SI B41 01 16  
Body

### Recall Campaign 16V-XXX: ISOFIX Child Restraint System Anchors

#### MODEL

F25 (X3)	F26 (X4)
----------	----------

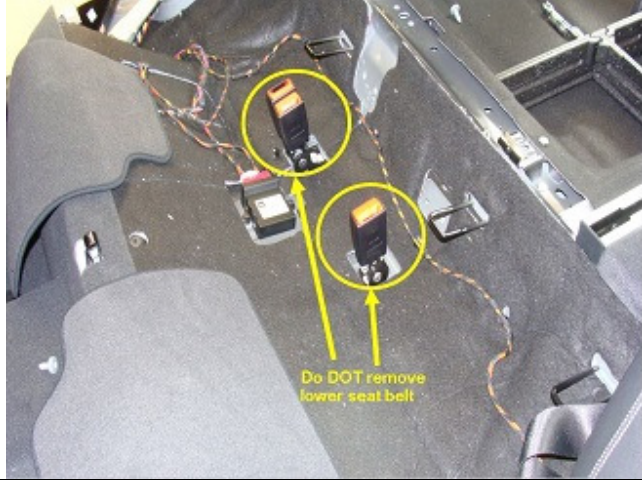
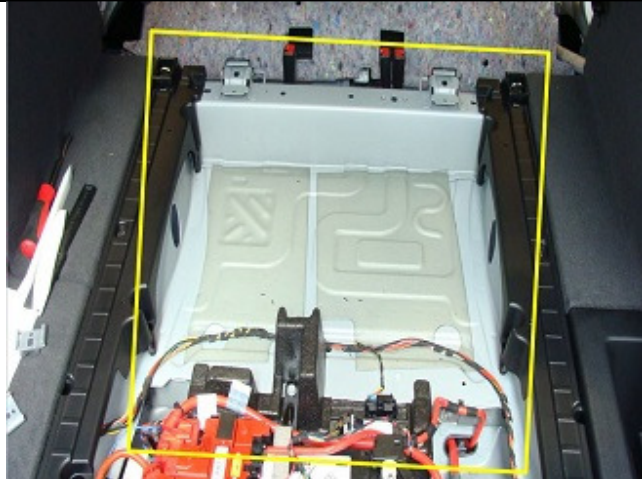
When specifically used with ISOFIX-type rigid-style connector child restraint systems, the lower anchor bars could become damaged over the lifetime of the vehicle.

A reinforcing bracket (4) will be welded to the lower anchor bars and the vehicle body.
